Re: Request for Information, Section 308 of the Clean Water Act ("CWA")

Village of Hewlett Bay Park Docket No. CWA-IR-17-018

Municipal Separate Storm Sewer System Permit NYR20A085 EPA Compliance Evaluation Inspection September 13, 2016

Compliance Evaluation Inspection: Hewlett Bay Park, MS4, Outfall Reconnaissance

DSCN3736

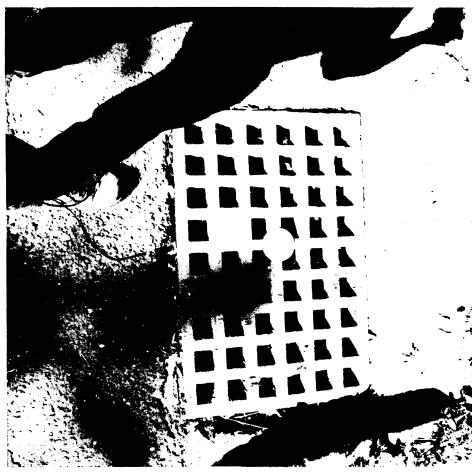
- 2. There was a catch basin near SW Outfall No. 2 on Everett Ave. near Willow pond, that may need to be inspected and cleaned if necessary, see photo 736
- 3. As shown in Attachment 3, the facility conducted its Outfall Reconnaissance surveys in April 2016. Please make sure to list the outfall number next to each of the locations visited.
